OKAGAWA FEDERAL 23A-33-692 (A-A')

Draft Questions:

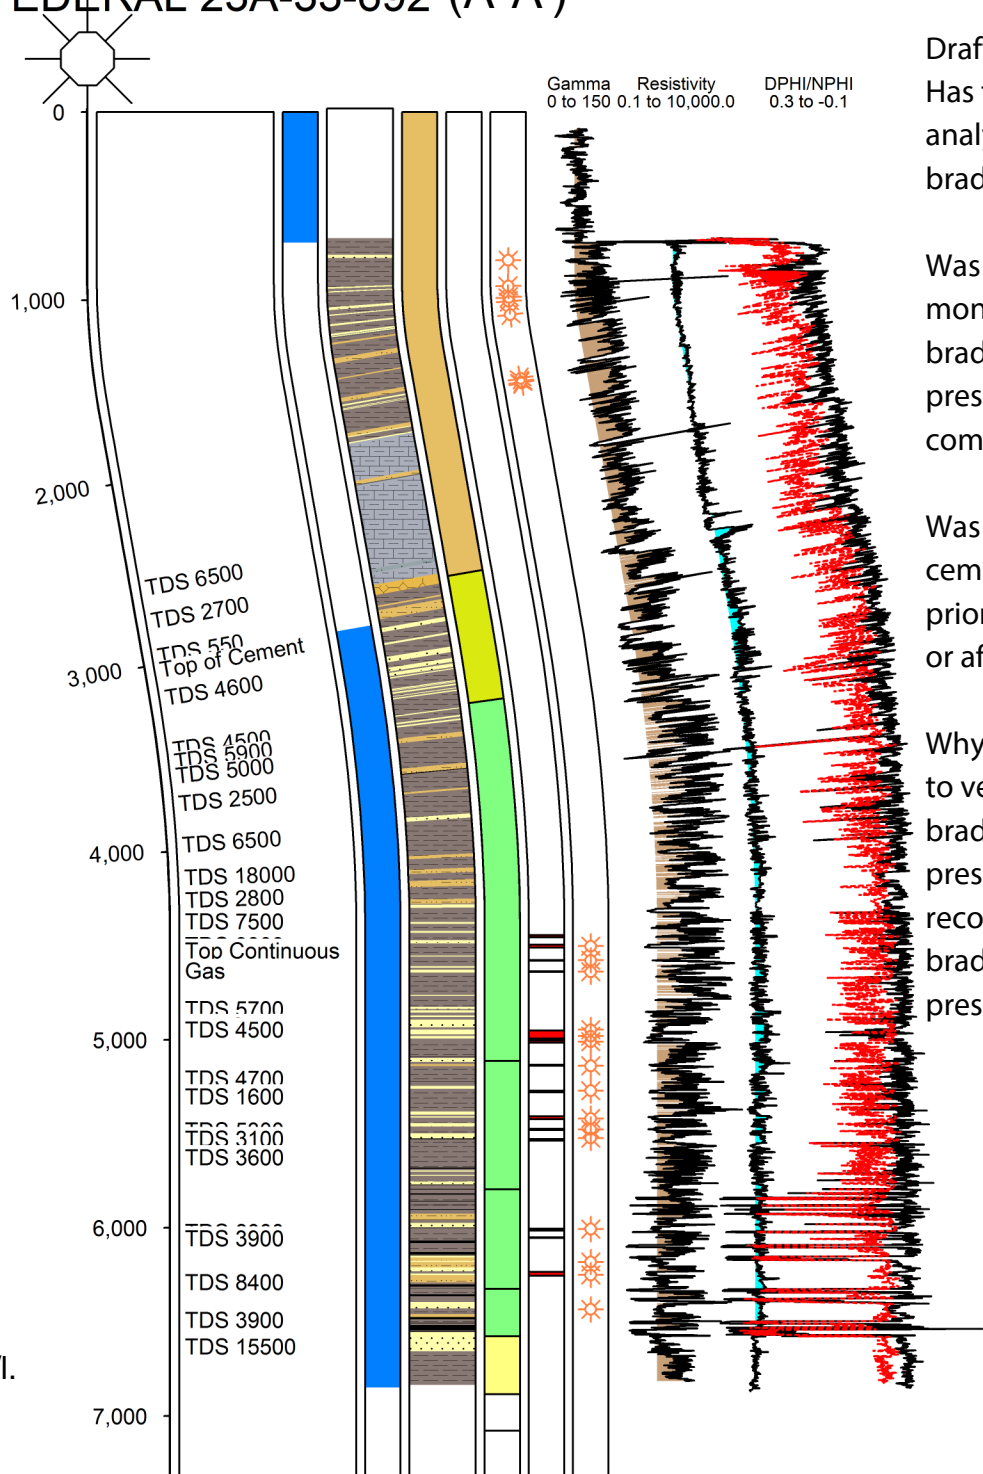
Has there been analysis of bradenhead gas?

Was there monitoring of bradenhead pressure during completion?

Was remedial cementing done prior to completion or after?

Why is it necessary to vent if the bradenhead pressure test recorded a final bradenhead pressure of 0 psig?

- 1.) Prior to completion, the pressure in the bradenhead annulus was 40 psig.
- 2.) On Request to Complete Sundry Notice, the operator identified poor cement bond from 3000 ft (top of cement) to 4880 ft.
- 3.) There are gas shows in the Williams Fork formation that are being produced and are in contact with the annulus with poor cement bond. There are also gas shows in the Wasatch formation in contact with the open bradenhead annulus.
- 4.) The 2013 and 2014 bradenhead pressure test reports from the operator specified the final bradenhead pressure as 0 psig.
- 5.) The 2015 inspection report specified that the bradenhead valve was open and that the well was venting.
- 6.) The calculated TDS in the lower Wasatch formation ranges from 2700 to 6500 mg/l.
